Re: Response to Submissions – Kingscliff Public School Redevelopment – SSD-8378620

Response to Submissions

Kingscliff Public School Redevelopment - (SSD-8378620)

Figure 2: Extract of Shadow Diagrams 9am Winter Solstice, SJB Architects, EIS

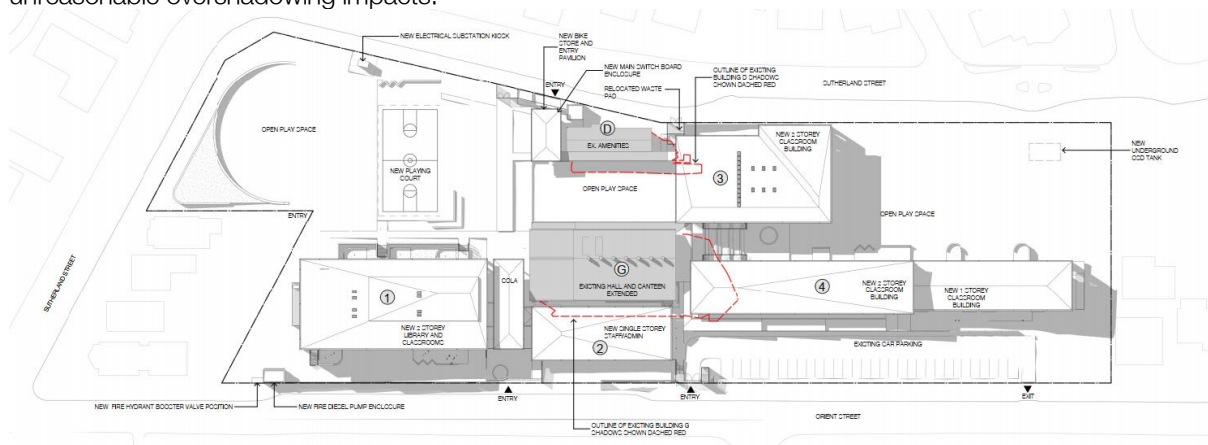
“Whilst solar access diagrams were provided in the EIS, an assessment of the impacts was not included. An assessment of the solar impacts must be provided.”

Response: As detailed in the EIS, the proposal will not have unreasonable shadow impacts. This is evidenced in the extracts of the shadow diagrams prepared by SJB Architects for 9am, 12 noon and 3pm at the winter solstice, included in Figures 2, 3 and 4.

The proposal has negligible overshadowing impacts on the adjoining properties to the south at 30 Orient Street and 17 Sutherland Street.

At 9am, a slither of additional overshadowing encroaches into 30 Orient Street by up to a maximum of 1.5m. However, from mid-morning onwards there will be no additional overshadowing to 30 Orient Street.

At 3pm, a similar slither of additional overshadowing encroaches into 17 Sutherland Street by up to a maximum of 1m (approx.). However, there is no additional overshadowing to No. 17 prior to 3pm.
